TCEC Cooling Tower Basin Sealing RFP
Pre-Bid Site Walkdown 9/30/25

TREASURE COAST ENERGY CENTER, PB1
CIRCULATING WATER
COOLING TOWER BASIN
PLAN, SECTIONS & DETAILS

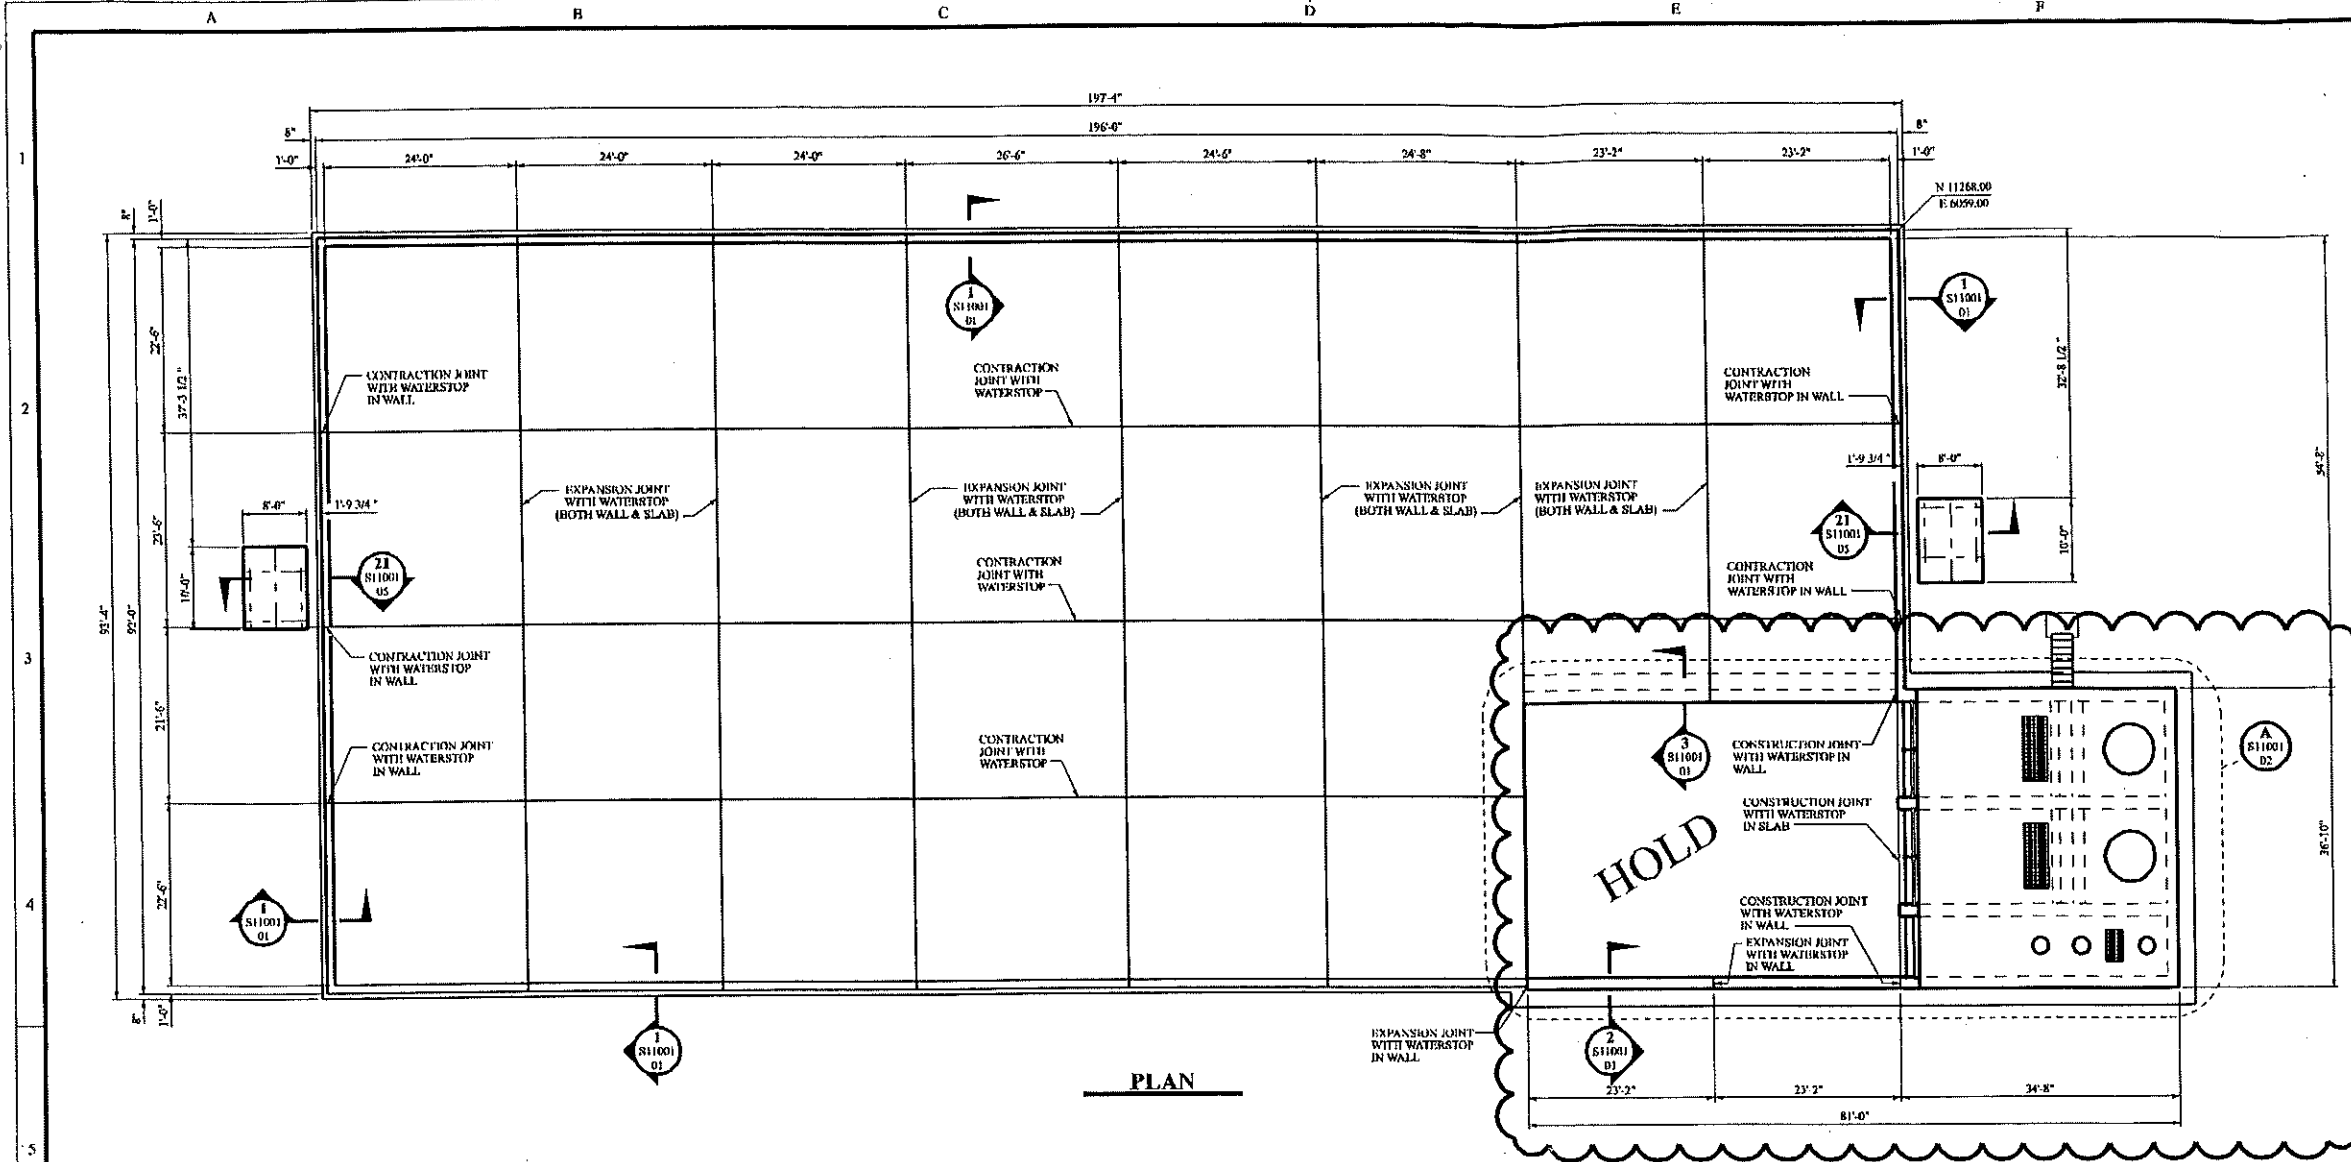
- **Question: Are the dimensions on the drawing handed out accurate?**
 - Response: Not necessarily. It is up to you as the vendor during this walk down to validate the dimensions. *For example, the caulking on the drawing calls out 1" width, but in the field the caulking appears to be at least 2" in width.*
